United States Nuclear Regulatory Commission  
Document Control Desk  
Washington, D. C. 20555-0001Subject: Response to Questions Regarding the 2002 Steam Generator Tube Inspections  
(TAC No. MB9541)

RESPONSE TO QUESTIONS ON LICENSEE'S RESPONSES  
TO REQUEST FOR ADDITIONAL INFORMATION  
DAVIS-BESSE NUCLEAR POWER STATION  
2002 STEAM GENERATOR INSPECTION (TAC No. MB9541)

**Voltage Distribution for Dents Between LTS and 14S**  
**DBNPS SG 2-A 02/02 13RFO**

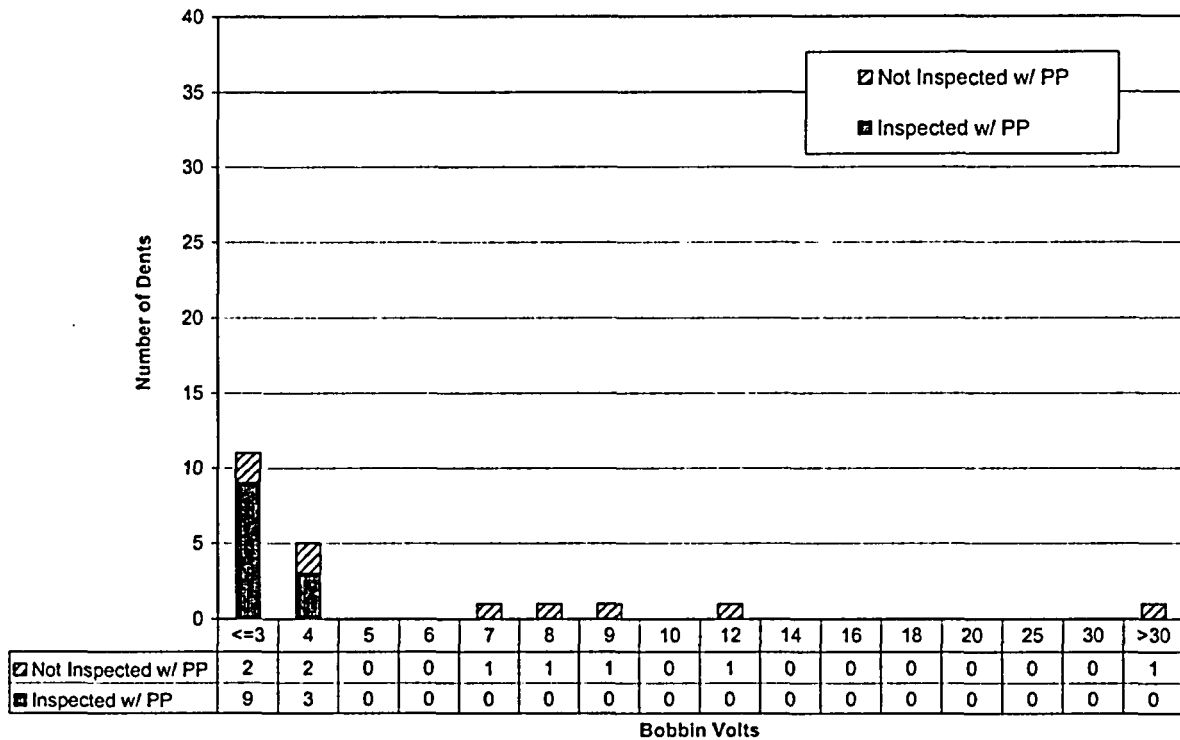
*For the dents not examined during the 2002 outage, please describe the methodology used to assess the integrity of these tubes for the period of time between inspections. Include in this response, the size distribution of the dents not inspected and an assessment of whether the bobbin would have detected axial and circumferential cracks at these locations (given the size of the dent).*

As previously stated, 100% of the dents located at or above the 14<sup>th</sup> TSP were inspected during 13RFO, and for dents below the 14<sup>th</sup> TSP, the DBNPS completed a 100% sample in three cycles with no indications of degradation present in any of the inspections. As requested, the figures provided below indicate the inspected versus uninspected population of dents in the region below the 14<sup>th</sup> TSP (not including dents at or in the LTS region) during the 13RFO inspection. Note that the 30 volt dent in A-61-109 was inspected in 12RFO with a +Point probe and no degradation was detected (dent present in history). Sampling in both OTSGs at the LTS sludge and dented region is accomplished under a separate inspection program.

As indicated in the Question #7 response above, no indications of cracking have been detected in dents below the 15<sup>th</sup> TSP at the DBNPS. Additionally, it is important to note the following observations regarding flaws in dents in OTSGs: 1.) In general, indications detected

in dented regions of OTSG tubes have been first detected and reported by bobbin coil (NQL); 2.) Indications have been OD in nature, and 3.) Specifically at the DBNPS, the indications that have been detected in dents have also been detected and reported via bobbin coil inspection of the area. These facts indicate that the crack morphology that occurs at dented tube areas in OTSGs and specifically at the DBNPS has enough axial and/or volumetric response to be detected by bobbin coil inspections.

no expansion of the dent inspection scope was performed at 13RFO and the tube integrity analyses did not include any adjustments for the uninspected dent population. As demonstrated by the Figures, the inspected population provided a sufficient interrogation of dents such that if degradation existed in this region, the sample would have been sufficient to provide a high probability of detecting active degradation in the sample. At the next scheduled inspection of the OTSGs, the DBNPS is planning on inspecting 100% of all dents in all areas of the OTSGs, as well as preventive plugging of significant dents in the region at or above the 14<sup>th</sup> TSP in the periphery (damaged from auxiliary feedwater (AFW) header issues), where existing conditions (temperature, flow, loads) could accelerate tube degradation at the dented area.
